## CITY OF MARLBOROUGH MEETING POSTING

Meeting: **Planning Board**  
Date: **December 21, 2020**  
Time: **7:00 PM**  
Location: **REMOTE MEETING NOTICE**

Subject: Four-Lot Subdivision, 76 Broad Street, Marlborough, MA  
**Response to Engineering Division review comments**

DEFINITIVE SUBDIVISION PLAN

SHEET: 12 OF 12

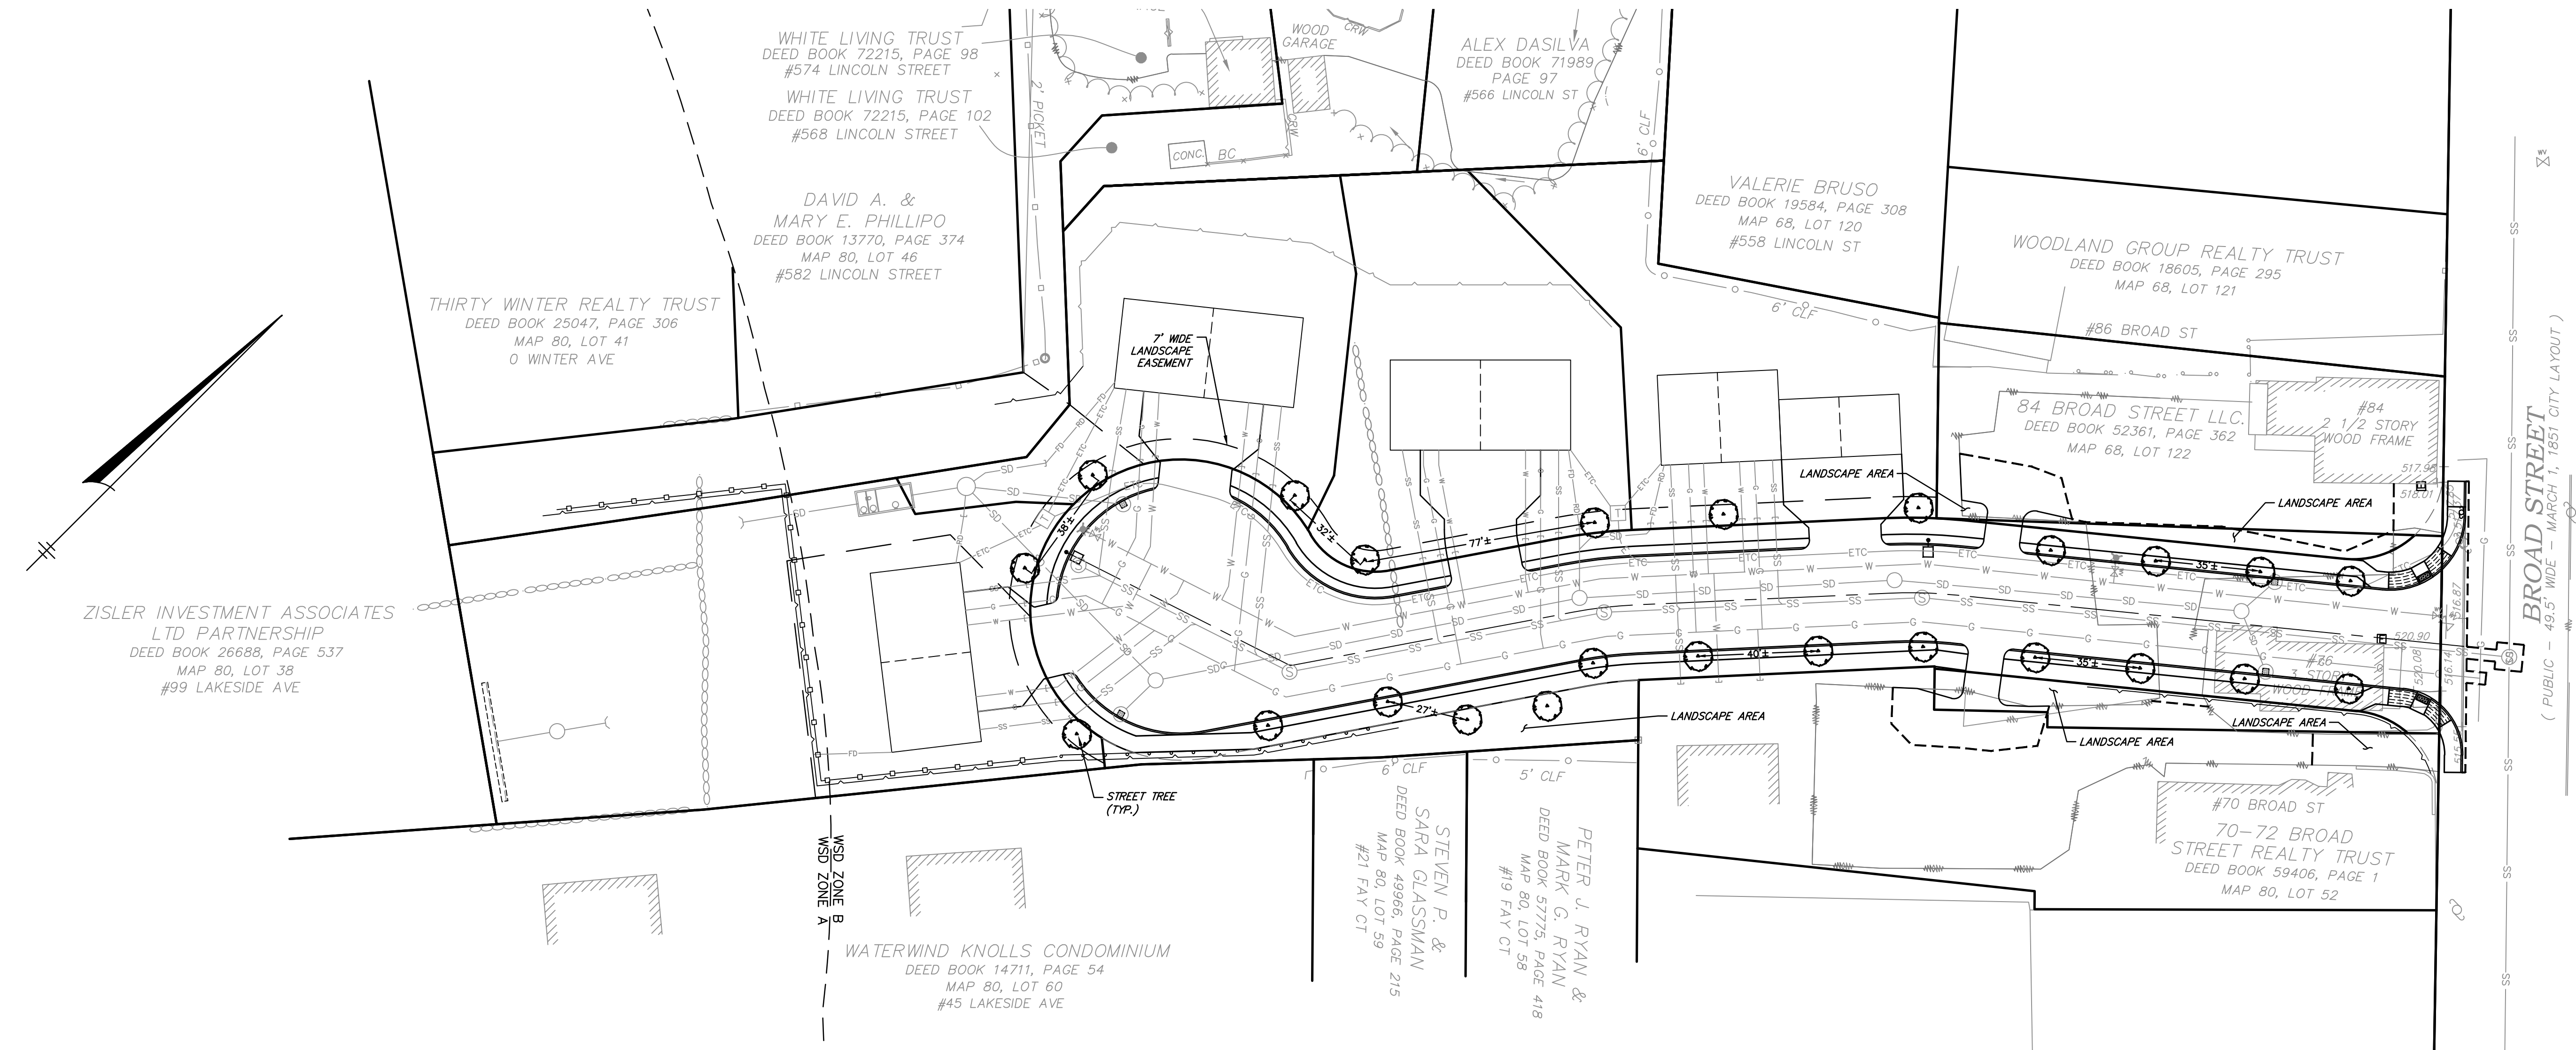
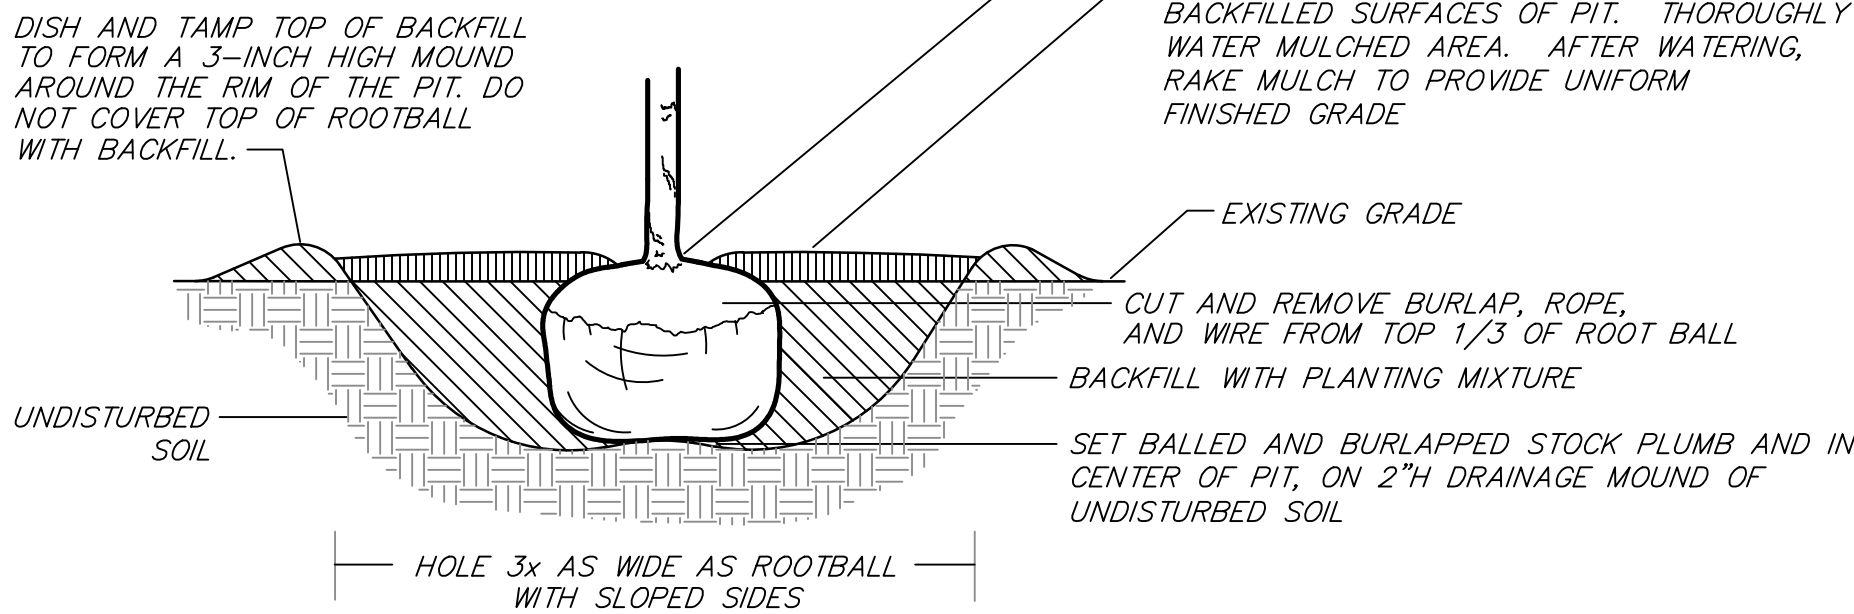
- A Landscape Easement for street trees should be shown. Given the small lots size and multiple utility connected that would be required for each of the building lots, a Landscape Plan should be provided to determine if trees can be planted at 40-foot intervals with at least 2 trees per lot. If this unattainable, then a variance under [§A676-28] Trees; will be required.

**Response: We respectfully request a waiver from bylaw §A676-28.A (see Requested Waivers, page 2). A Landscape Plan has been added to the plan set (C12).**

**The Landscape Plan (C12) depicts the proposed landscaping.**
